Revised Access Report

Accessibility Review Report – DA Review

Project Title: East Quarter Residential Development
St Leonards South - East Quarter (Lot 18,19 & 20)

Report Version: 21488_ADR_v1.2

Cl. D3.2: Access to Buildings

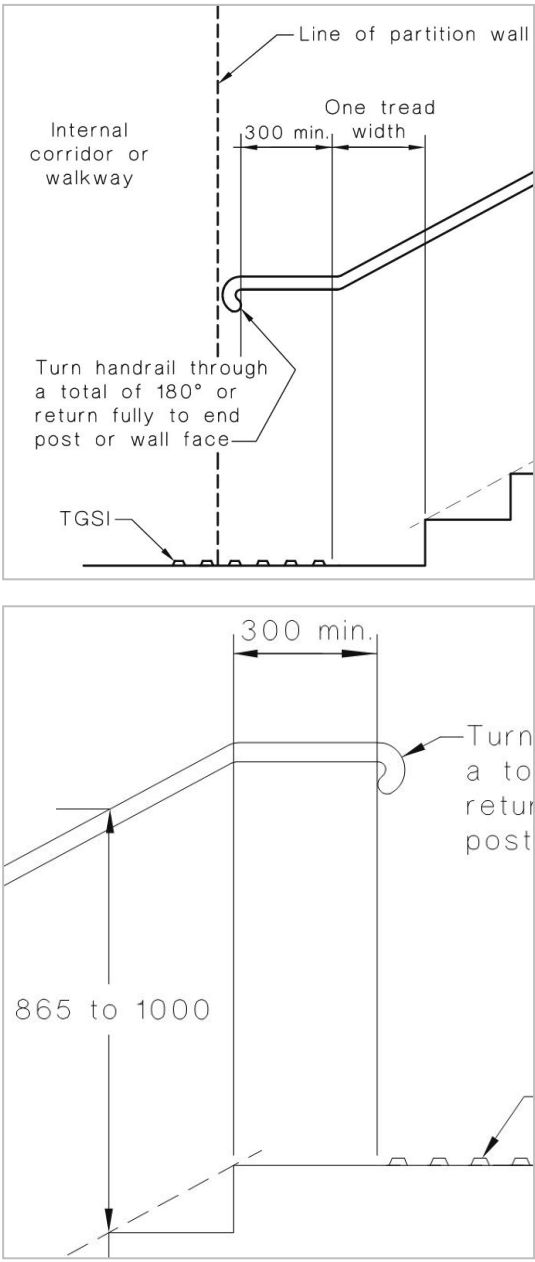
| | <p>between new and refurbished/ internal and external areas (<i>refer to example below or attached mark-up</i>).</p> <p>Paths of travel</p> <p>All pathways require a minimum unobstructed width of 1000mm. Pathways shall not include impediments such as steps or turnstiles without an accessible alternative provided.</p> <p>Circulation spaces prescribed by AS1428.1-2009 are required at changes in direction and other circumstances may require a greater width than 1000mm.</p> <p><u>Design Detail:</u></p> <p>Verification of slip resistant surface finishes on all accessways should be provided prior to OC sign off. It is recommended to refer to HB-198 for area ratings and test in accordance with AS4586-2013.</p> <p><u>Design Detail:</u></p> <p>Ensure any tracks/grooves (including for water shedding or sliding doors) and grate slots/holes are no greater than 13mm wide (depending on orientation) and are recessed to maintain flush/level pathways.</p> <p>7.5 Grates</p> <p><i>Grates shall comply with the following:</i></p> <p><i>(a) Circular openings shall be not greater than 13 mm in diameter.</i></p> <p><i>(b) Slotted openings shall be not greater than 13 mm wide and be oriented so that the long dimension is transverse to the dominant direction of travel.</i></p> <p><i>NOTE: Where slotted openings are less than 8 mm, the length of the slots may continue across the width of paths of travel.</i></p> | |

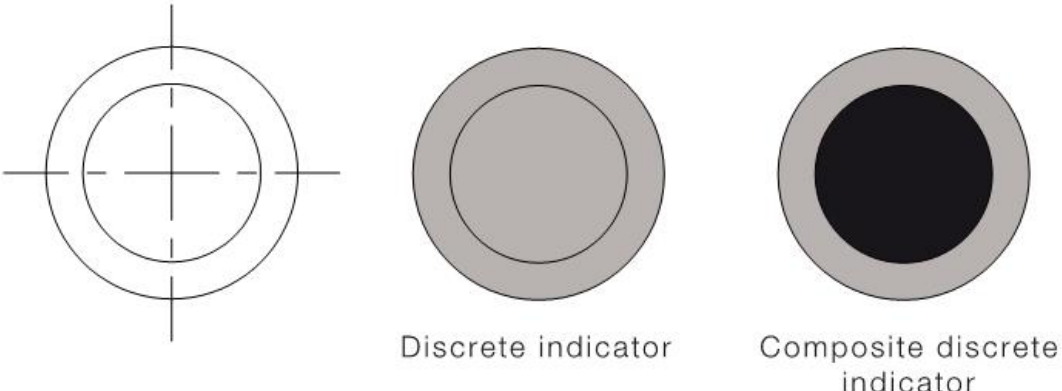
| DtS Provision | Status |
|--|---------------|
| <p>In a building required to be accessible signage complying with Spec. D3.6, AS1428.1-2009 and incorporating the appropriate recognised symbol (as appropriate) for persons with disability must be provided as follows —</p> <ul style="list-style-type: none"> • braille and tactile signage must identify each sanitary facility and space with hearing augmentation; • braille and tactile signage must identify each door required by E4.5 to be provided with an exit sign and state “Exit” and “Level” followed by the floor level number; • signage must be provided within a room containing a hearing augmentation system identifying; the type of system, the area covered within the room and if receivers are being used and where the receivers can be obtained; • signage must be provided for accessible unisex sanitary facilities to identify if the facility is suitable for left or right handed use; • signage to identify an ambulant accessible sanitary facility must be located on the door of the facility; • directional signage where a pedestrian entrance is not accessible. • directional signage where a bank of sanitary facilities are not provided with an accessible sanitary facility. <p>Signage shall be installed in accordance with and a design/install certificate is to be provided to confirm compliance with the relevant provisions of the BCA and Australian Standards.</p> | DD |

Accessible Entrance

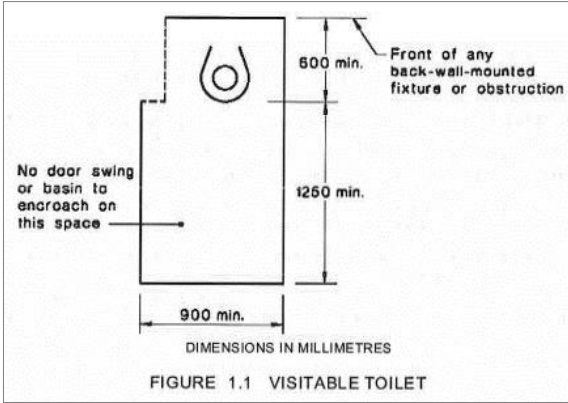
| Requirement/Specification | Comment(s)/Recommendation(s) | | | | | | | | | | | | | | | | | | | | |
|--|---|-----------------------------------|-----------------------------------|-----------------------------------|-----------------------------------|-----|------|-----|-----|-----|------|-----|-----|-----|------|-----|-----|------|------|-----|-----|
| 1x accessible entrance complying with AS1428.1-2009 is to be provided. | <p>Compliance is readily achievable with minor design development and/or specification AS4299 & AS1428.1 at the Detailed Design Stage.</p> <p><u>Design Detail:</u></p> <p>Ensure visitable front doors can achieve clearance and circulation space to AS1428.1-2009.</p> <div>
